The short and winding road to the Leisure Centre

Disappointments

Option 1 – Shared Use Facility on the Western Side of Barfield Close

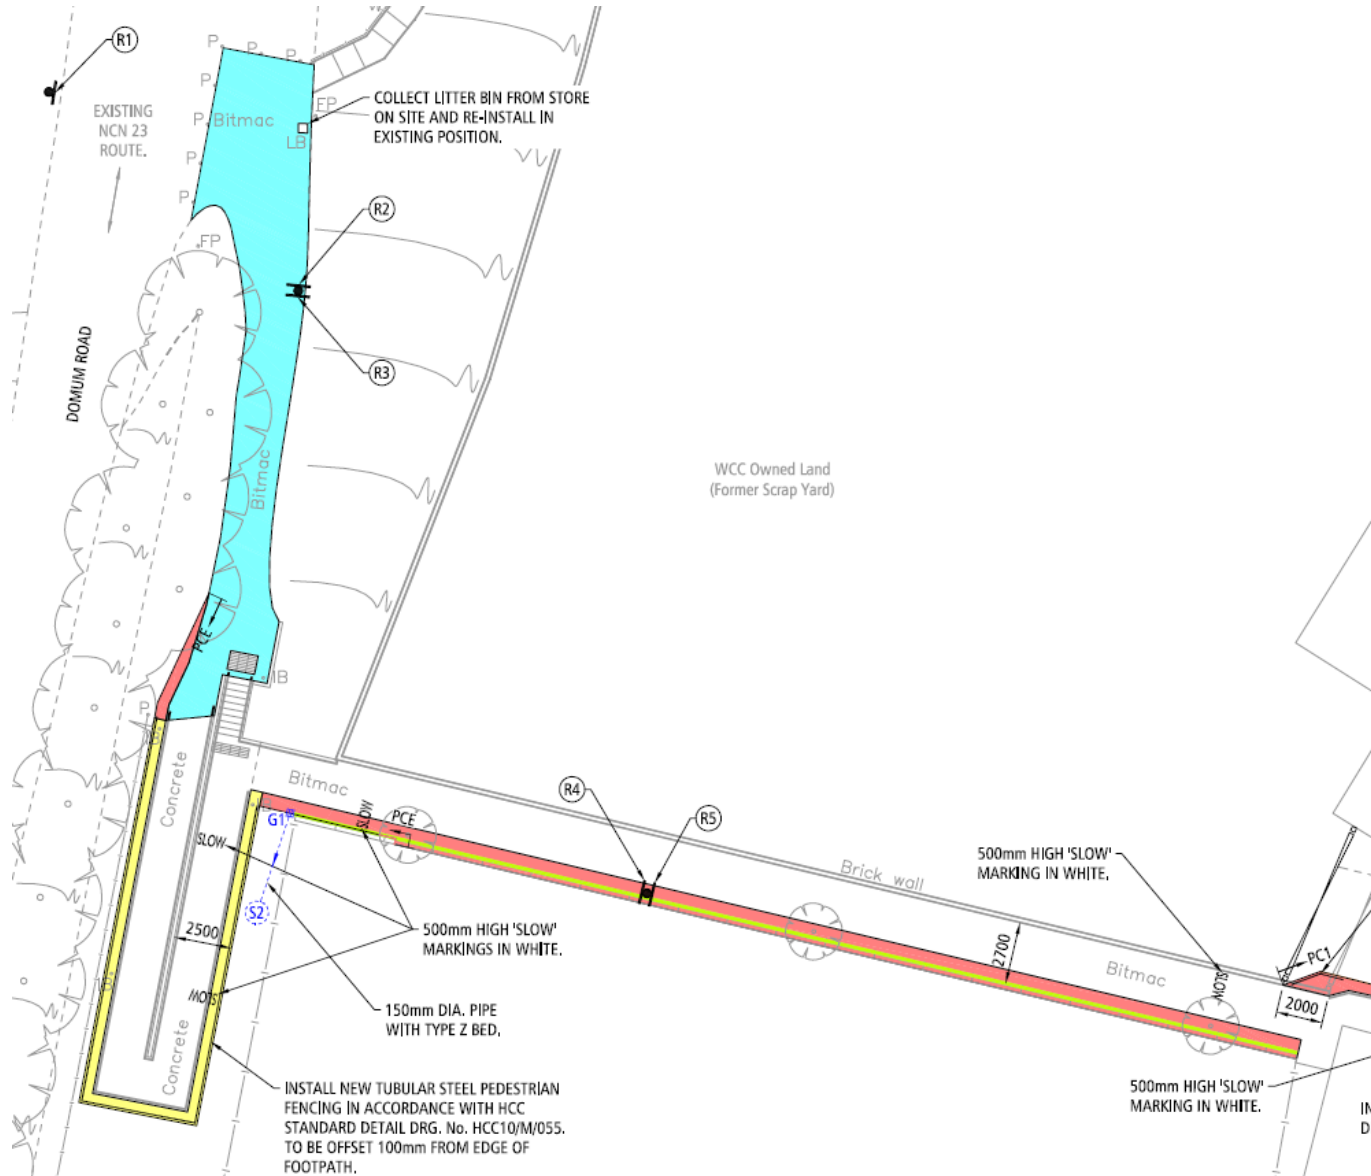
The conditions require the review's proposals be implemented, including one of the options for cycling facilities along Barfield Close. Plans were produced for option 1 but not carried out.

Figure 17-1 Diagram 1001.5 (S14-2-53): Road markings indicating a Parallel crossing

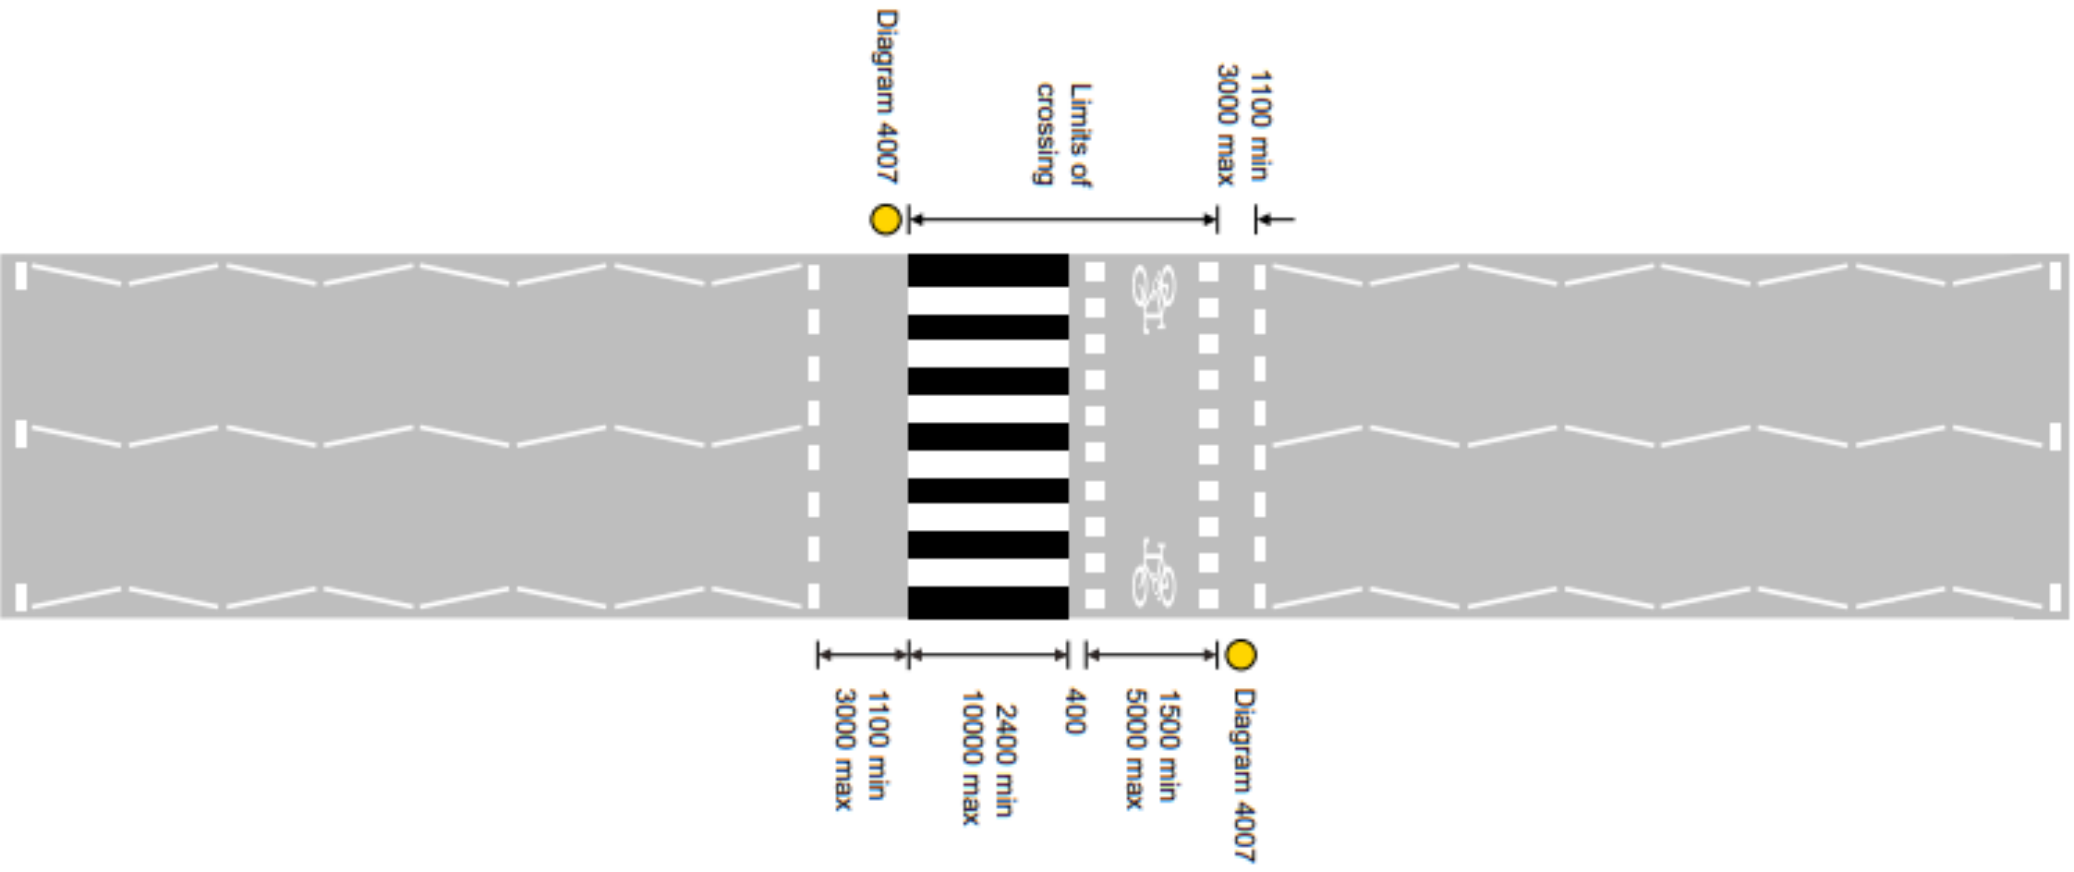
The markings seem to reflect the DfT diagram in their 2019 traffic signs manual chapter 6 (see next slide). Perhaps more important, it may be worth reassuring cyclists, and warning drivers that bicycles have priority, since parallel crossings date only from 2016, and many people will not have seen them before. 'Cycle crossing' warning signs, and contrasting colour surface could improve safety. While the crossing itself follows the DfT guidance closely, the approaches from both directions are highly unsatisfactory.
